Interactive comment on “Overview of the O3M SAF GOME-2 operational atmospheric composition and UV radiation data products and data availability” by S. Hassinen et al.

S. Hassinen et al.

Received and published: 30 November 2015

Referee #2 Anonymous

Fig. 1.

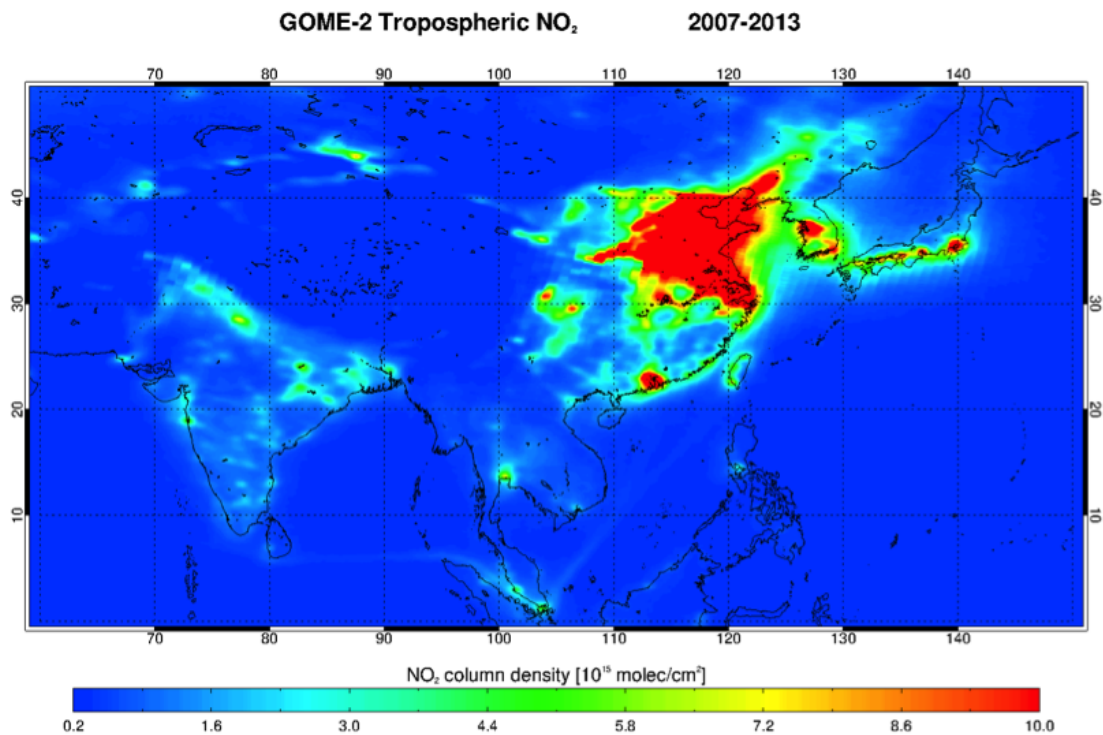
Question: Figure 5 shows an average tropospheric NO₂ column. I don't like the use of the nonlinear color scale for this figure. The text focuses on the high values in China, but due to the choice of the color scale this is one red blob without any variability. Also, depending on the target audience (see general comments), one should be very careful in the use of non-linear scales.

Note: Fig 5 is now Fig 7 due to structural changes.

The main purpose of Fig 5 is to illustrate various different NO₂ features, e.g. the extreme pollution over Eastern China, the individual cities in South East Asia, as well as the shipping tracks in the Bay of Bengal and the South China Sea (see comment below). Because these features cover very different NO₂ levels (from 5 × 10¹⁴ molec cm⁻² to 2 × 10¹⁶ molec cm⁻²), a map with linear color scale does not properly illustrate these features (see Fig. 1 below). In the manuscript, we have improved Fig. 5 by adjusting the values range. In the figure caption, we mention the logarithmic scale used for the NO₂ map.

Fig. 7 Average tropospheric NO₂ columns over East Asia measured by GOME-2 for 2007-2013 (linear color scale)

Fig. 2.

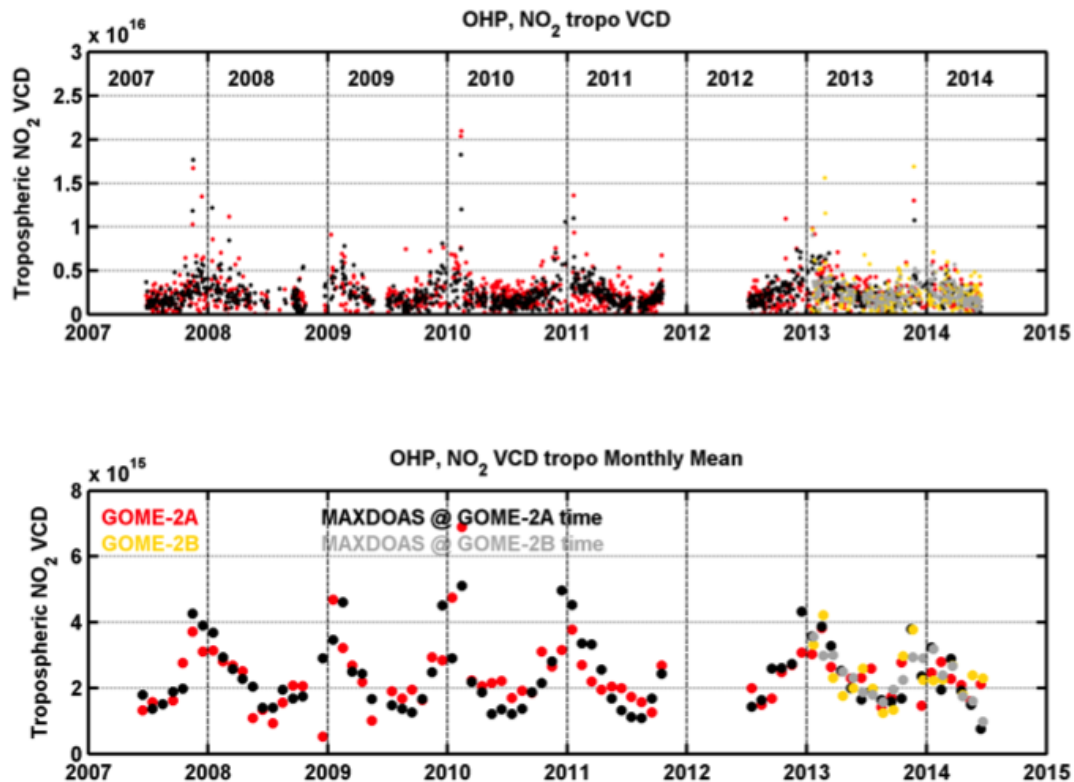
Question: Figure 6. What do the error bars represent? This figure could be further improved by using box-whisker plots.

Answer: Note: Fig 6 is now Fig 8 due to structural changes

The error bars represent the 1 sigma spread (68% of the points) around the median value, ie, plus and minus $(\text{Interq}_{84} - \text{Interq}_{16})/2$. We agree with the reviewer that this figure could be improved by using box-whisker plots, but our approach in the current figure 6 is quite similar, and the goal in this paper is to show examples of validation results (performed in details in the validation reports themselves) for both GOME-2A
